### Lynx Time Code Module Circuit Board Modifications

DATE: 03/10/94  
MODEL: Lynx Time Code Module  
REVISION: All  
SERIAL NO: Serial numbers below 3280\* (See Description)

This procedure permanently converts the REV. A version of the Lynx Module's main PCB to use 256k PROMs instead of the 128k PROMs originally installed in early modules. Once this procedure has been completed, the module cannot use 128k PROMs; all current software versions are available on 256k PROMs.

Figure 2. PROM Location

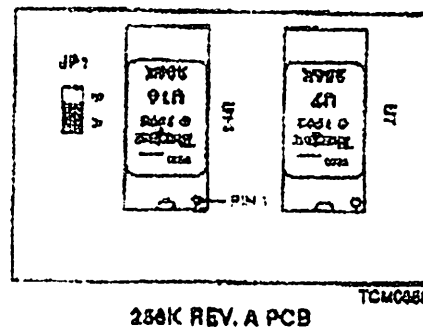
- a. On the component side of the main circuit board, carefully cut the circuit trace going to Pin A of JP1 (trace goes between two legs of U16's socket).
- b. Move the jumper on JP1 to the 'A' position.
- c. On the solder side of the main board, carefully cut the circuit trace that connects Pin 27 and Pin 28 of U7. Also, carefully cut the circuit trace that connects Pin 27 and Pin 28 of U16.
- d. Install a jumper from JP1-a to Pin 28 of U48.
- e. Install a jumper between U48 Pin 27, U16 Pin 27, and U7 Pin 27.
- f. Remove the 128k PROMs from U16 and U7 (if installed).

- g. Carefully install the 256k PROM(s) in the appropriate socket(s). Current software is supplied on a pair of chips labeled U7 and U16. Be careful to correctly align Pin 1 and properly seat the PROM(s).
- h. Locate and remove U48, the 8031 micro processor. Replace with the 8032 micro processor (TimeLine Part Number 24P002).

Figure 3. Component Location for Step I, 1 and 2

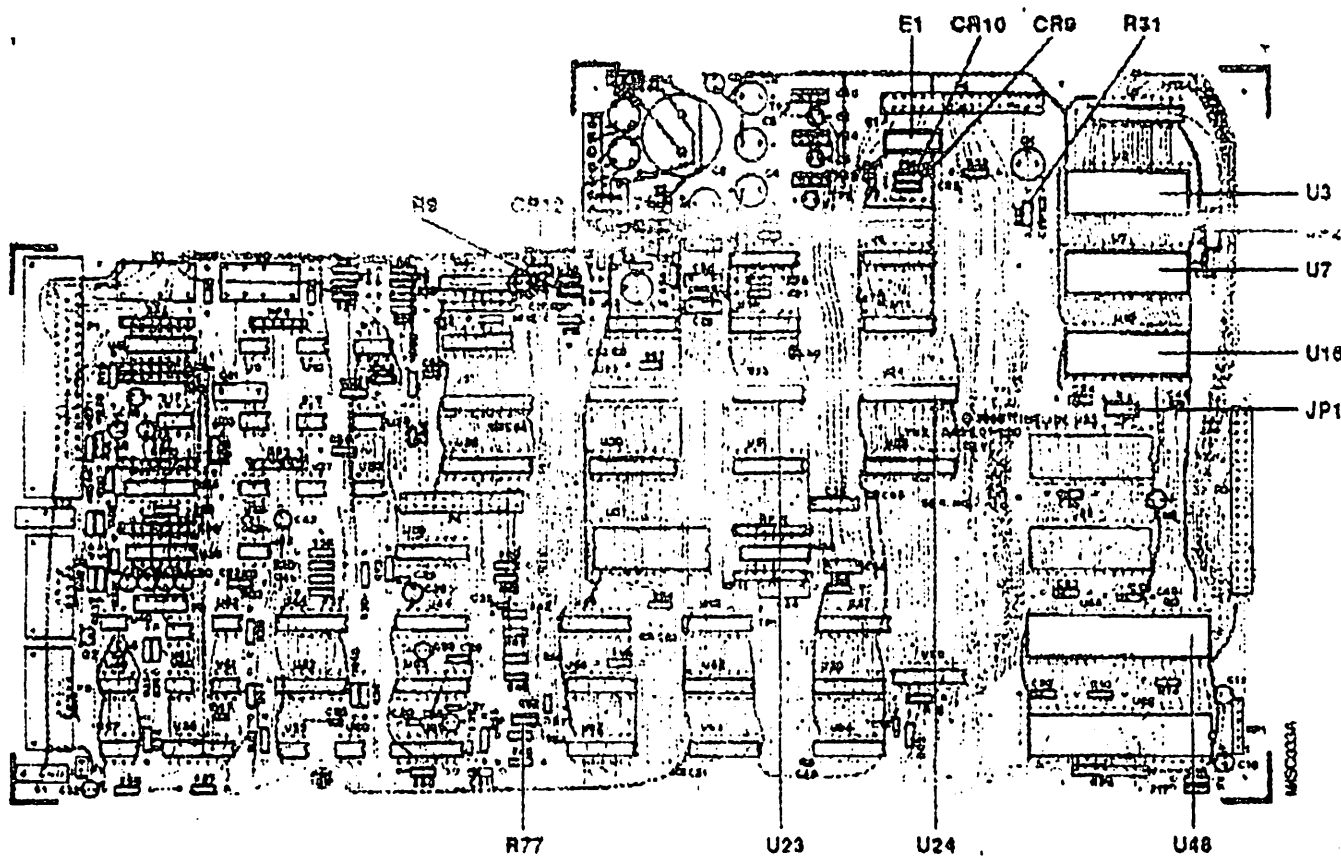
- a. Remove lithium battery E1 from main PCB.
- b. Remove diode CR10 (1N5711) from main PCB.
- c. Remove resistor R9 (100 k $\Omega$ ) from main PCB.
- d. Remove diode CR9 (1N5711) from main PCB and replace with an insulated bus wire jumper.
- e. Remove components at CR12 (1N914 diode plus paralleled 1 M $\Omega$  resistor) from main PCB and replace with an insulated bus wire jumper.
- f. Change R77 from 10 k $\Omega$  to 100 k $\Omega$  (This change may already have been done in some modules).
- g. Replace resistor R31 (10 k $\Omega$ ) on main PCB with a 2.2 k $\Omega$  resistor.
- h. Remove old RAM chip from U3 on main PCB.
- i. Install Dallas DS1220AB in U3 on main PCB. (TimeLine Part Number 24L001)
- j. Make sure that jumper JP2 is in position B.

Figure 4. Modification, Solder Side for Step 1, 3f and g

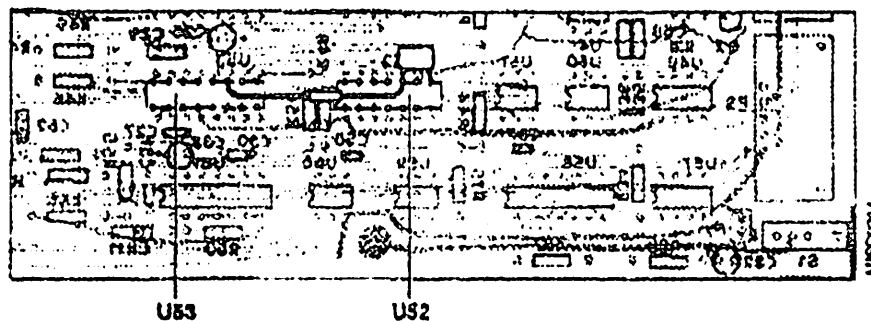
- e. Install insulated wire jumper from U53 Pin 5 to U43 Pin 6 on solder side of main PCB.
- f. Install .001 $\mu$ F capacitor from U52 Pin 5 to U52 Pin 7 on solder side of main PCB.

- g. Install 10 k $\Omega$ , 1/4 watt resistor from U52 Pin 5 to U53 Pin 5 on solder side of main PCB.
- h. Replace resistor R49 (43 k $\Omega$  or 47 k $\Omega$ ) on main PCB with a 33 k $\Omega$  resistor.

Figure 5. Component Location Step I, 3 - 6

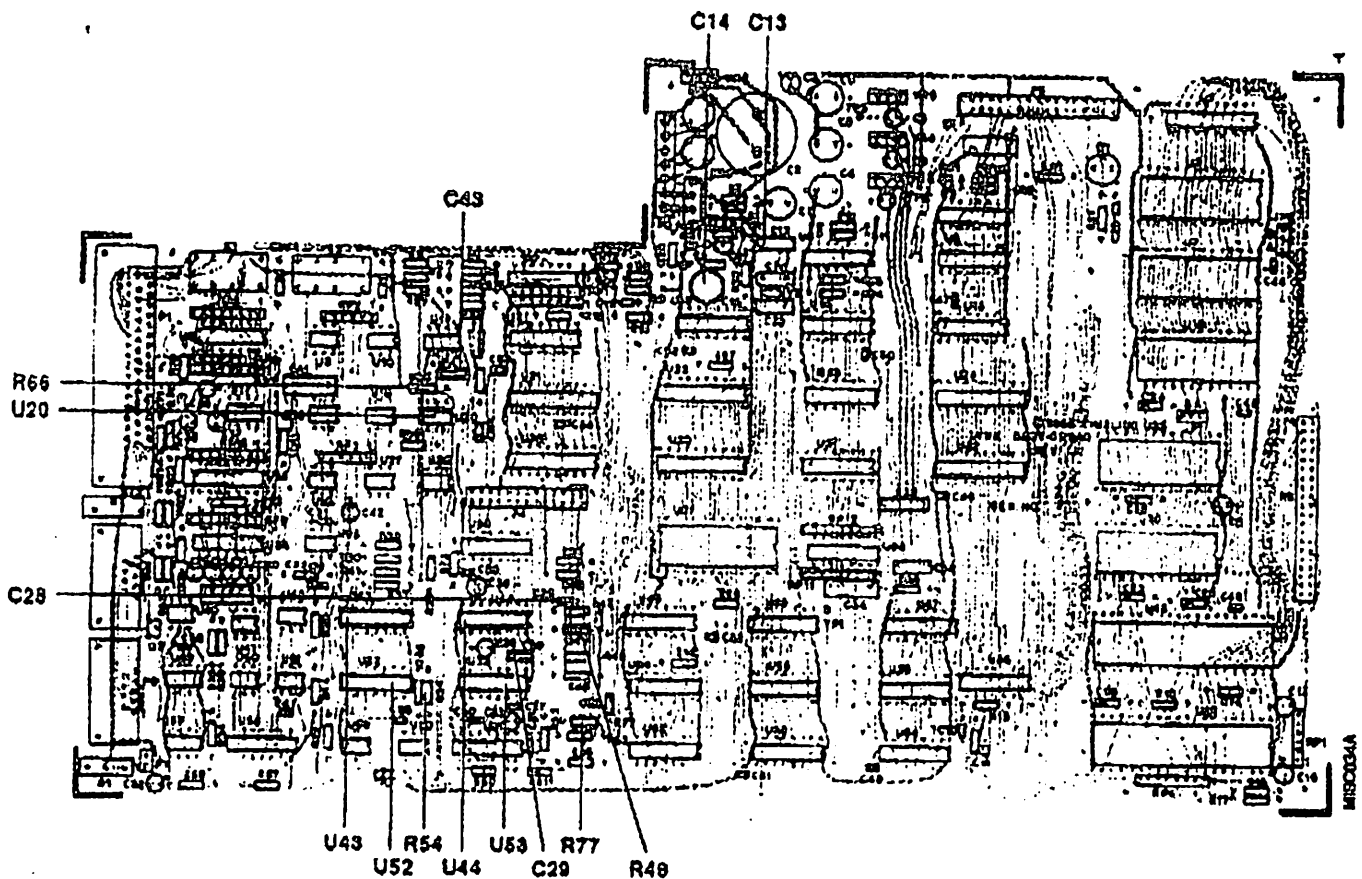
- a. Cut trace between U52 Pin 5 and U43 Pin 6 on component side of main PCB.
- b. Cut trace between U52 Pin 5 and U53 Pin 2 on solder side of main PCB.

- c. Cut trace between U43 Pin 9 and U44 Pin 10 on solder side of main PCB.
- d. Install insulated wire jumper from U43 Pin 9 to U44 Pin 9 on solder side of main PCB.

- i. Replace resistor R54 (5.1 k $\Omega$ ) on main PCB with a 1 k $\Omega$  resistor.
- j. Replace capacitor C28 (220 pF) on main PCB with a 10 pF capacitor.

- k. Replace capacitor C29 (.001  $\mu$ F) on main PCB with a 10 pF ceramic capacitor.
- l. Remove CD4528 from U44 (on main PCB) and replace with 74HC4538. (TimeLine Part Number 24D018.)

- a. Replace capacitor C13 (33 pF) on main PCB with a 22 pF ceramic capacitor.
- b. Adjust trimmer capacitor C14 on main PCB. Set frequency of Pilot Out signal as close as possible to 59.9400 Hz (or 16.68335 ms period) with SAL software installed, and generator set to GEN NTSC and INT XTL.

5. Capstan Frequency Output Optoisolator Modification<sup>®</sup>
  - a. Verify that optoisolator has been removed from U20 on main PCB and replaced with a 75Ω resistor from U20 Pin 2 to U20 Pin 5. (On some modules the optoisolator may already have been removed and a 10Ω resistor or a wire jumper installed; this should be replaced with a 75Ω resistor.)
6. Resistor Change in Capstan Control Frequency Generator  
Applies to: All Lynx Modules prior to S/N 1110.
  - a. Replace resistor R66 (22 kΩ or 100 kΩ) on main PCB with a 10 kΩ resistor.
  - b. Verify that capacitor C43 is .001 μF.

Figure 6. Component Location Step I, 8 and 9 through Step II, 1 - 5

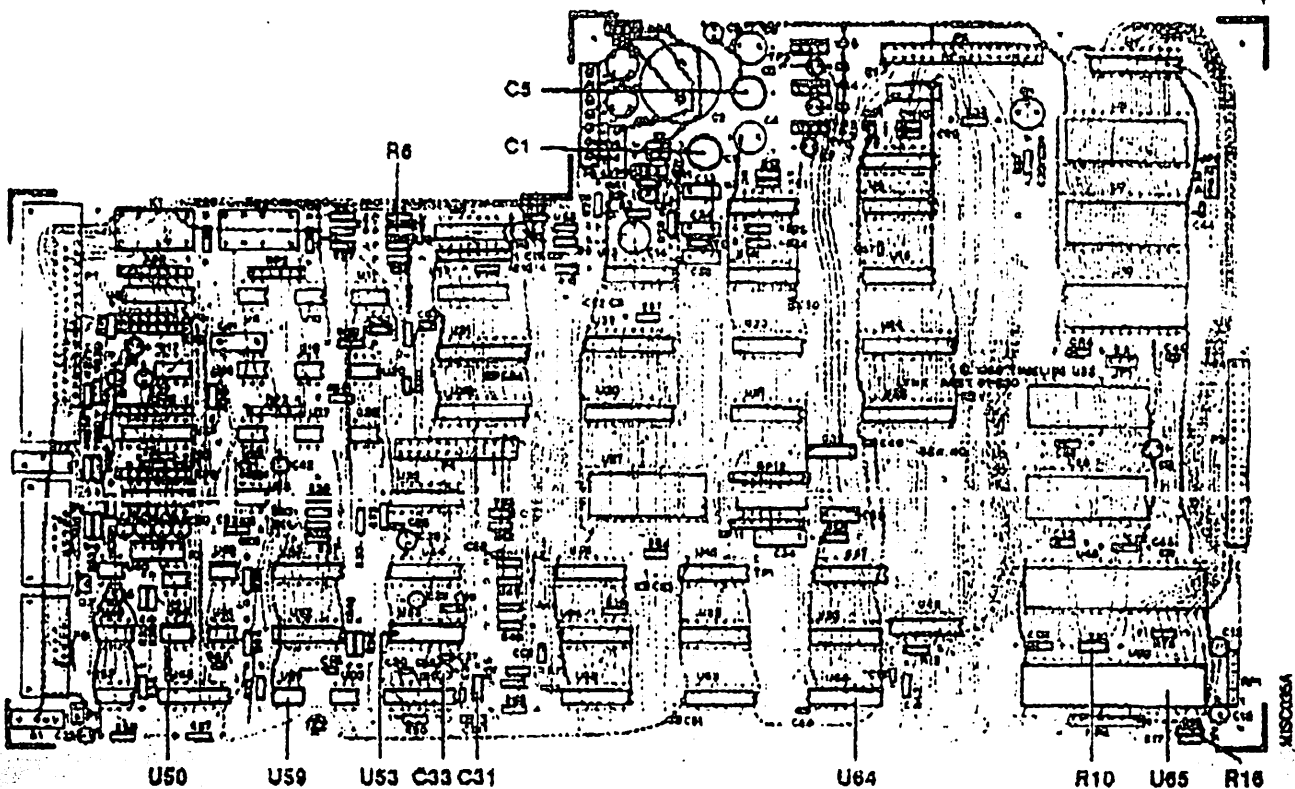
- a. Remove the 8256 chip from U65 on the main PCB.
- b. Bend Pin 12 of the chip outward so that it will not go into the socket.
- c. Reinsert 8256 chip in U65 on the main PCB with Pin 12 not inserted into the socket.
- d. Attach an insulated wire jumper to Pin 12 of the 8256 chip.
- e. Attach the other end of the jumper wire to the leg of resistor R10 (8.2 k $\Omega$ ) that is closer to the front of the module.

- a. If H11G2 optoisolator is found at U59 on main PCB, replace it with a 4N37 optoisolator.

- a. Examine tantalum bead capacitor C33 (1  $\mu$ F) on the main PCB and make sure that the banded side of the capacitor is facing the + marking on the PCB (toward the front).

- a. Remove capacitor C31 (10 pF) from the main PCB.

- a. Install a 470  $\mu$ F, 35 volt electrolytic capacitor at C1 on the main PCB.
- b. Solder an insulated bus wire from the positive lead of C1 (toward R1) to the positive lead of C5 (toward VR4).

- a. Replace resistor R16 (10 k $\Omega$ ) with a 22 k $\Omega$  resistor.
- b. Replace resistor R6 (200 k $\Omega$ ) with a 6.8 k $\Omega$  resistor.

Figure 7. Reader Card Component Location

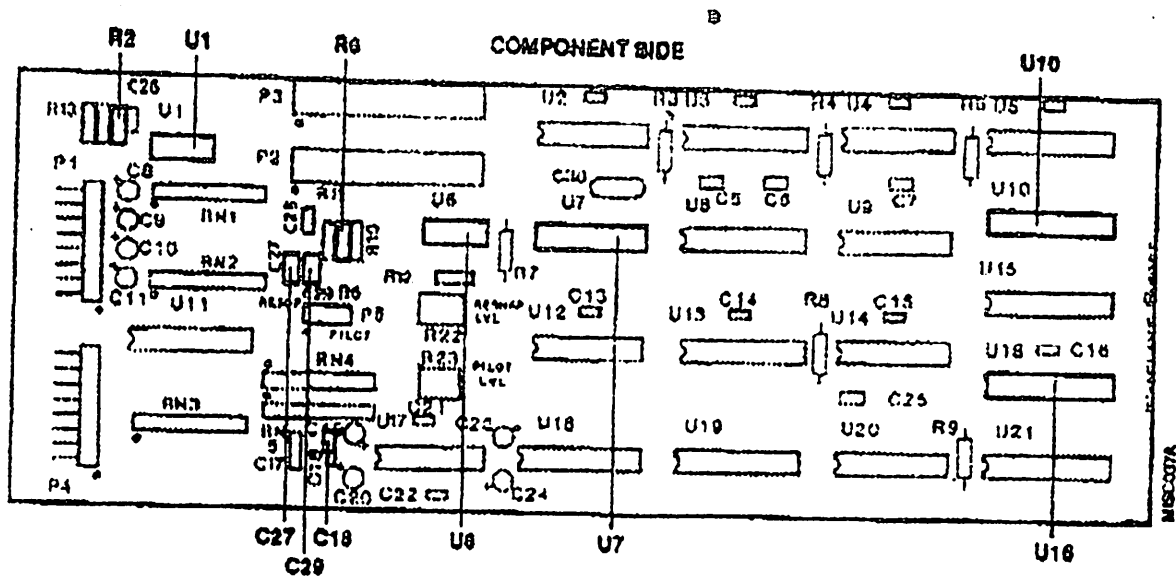
- a. Install 20 pF ceramic cap on solder side of reader PCB from U7 Pin 8 and U7 Pin 10.
  - b. Verify that C18, C27, and C29 on reader PCB are all .1  $\mu$ F monolithic ceramic capacitors. (Correct value marking: "104")

- c. Verify that a 2.2 M $\Omega$  resistor is connected between U1 Pin 3 and U1 Pin 8, and between U6 Pin 3 and U6 Pin 8 on reader PCB.
  - d. Verify that R2 and R6 on reader PCB are 470 k $\Omega$  rather than 2.2 M $\Omega$ .

3. **Toshiba Reader Chip Replacement**
  - a. If Toshiba brand 74HC40103s are found in positions U10 and U16 on the time code reader PCB, replace them with the same device type from a different manufacturer.
